申請編號：TPB/A/YL-PH/1070

再次提議渠務報告 (RE-Proposed)

1. 回覆 2025 年 10 月 14 日收到的渠務署意見（簡介）
2.
 - a. 申請人提議的渠管道建造是由申請人自費的。
 - b. 申請人提議的渠管道日後維修保養是申請人的責任。
 - c. 申請人提議的渠管道，也明白地權是政府/私人的。
 - d. 申請人承諾會得到政府部門同意/私人地段同意才會建設渠道工程。
 - e. 申請人聘任 PERRY LEE BUILDING CONSULTANCY COMPANY 公司
作此次渠務顧問

d1-1 Secation

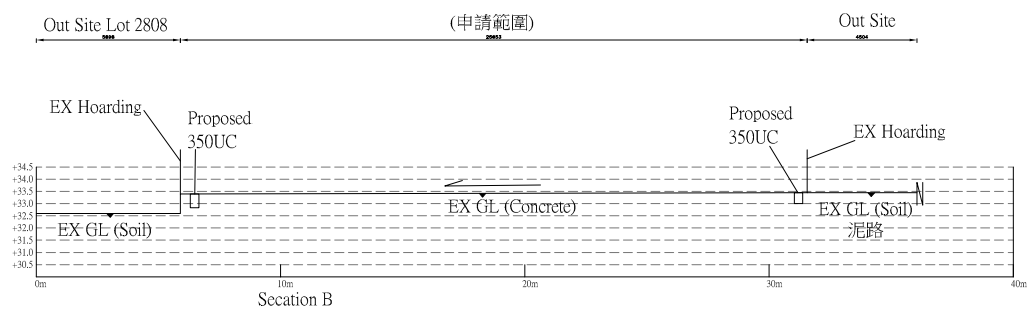
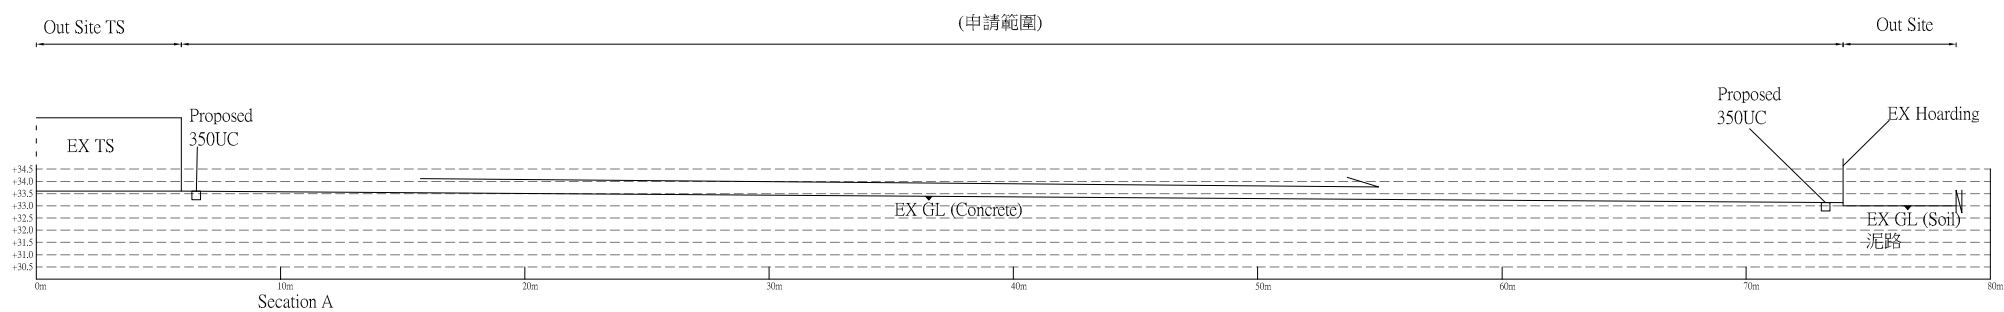
(g) Cross sections showing the existing and proposed ground levels of the captioned site with respect to the adjacent areas should be given.	在d1-1中示
(h) Standard details should be provided to indicate the sectional details of the proposed u-channel and the catchpit/sand trap.	在b4-1, b5-1, b6-1 b7-1 中示
